This Service Information bulletin supersedes SI B11 06 13 **dated October 2013**.

**Service Action: Retrofit Bracket for EGR Cooler**

E70 (xDrive35d)

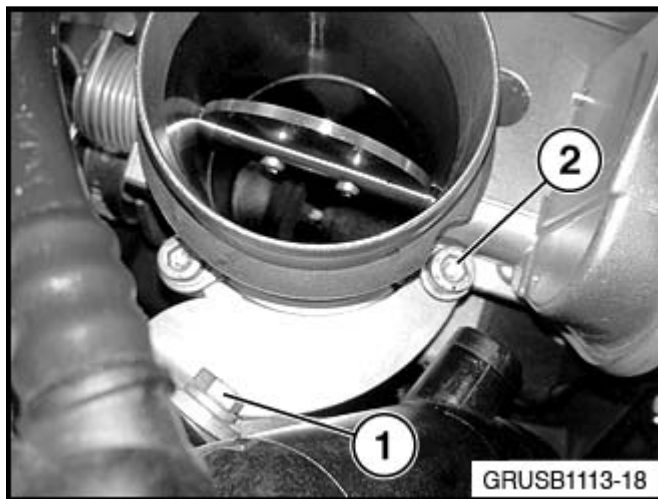
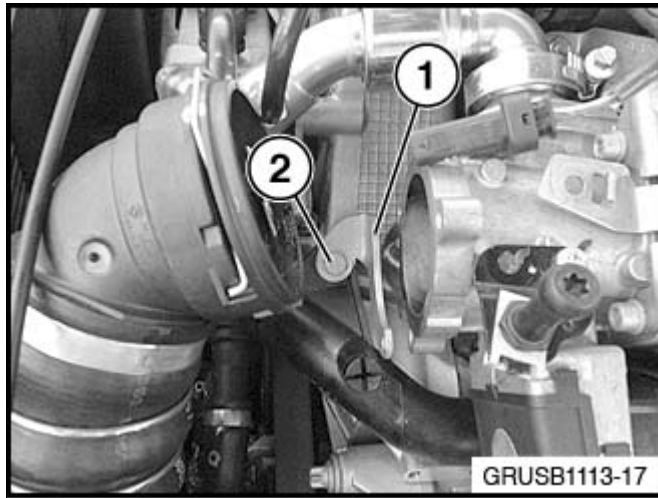
<p>Install bracket P/N 13 54 8 576 446 (1) to the cylinder head using the bolt P/N 07 11 9 904 527 (2). Leave this bolt finger tight until after the throttle valve is reinstalled. <b>NEW</b> Note: If the EGR cooler is leaking at the flexible elbow, replacement is necessary.</p>
--	--

Reinstall the throttle valve and snug down all three throttle valve screws. Torque the two screws that are not attached to the new bracket to specification (8Nm). Tighten down the bracket bolt on the cylinder head (1) to 8Nm. Tighten the screw (2) holding the bracket to the throttle to 8 Nm.
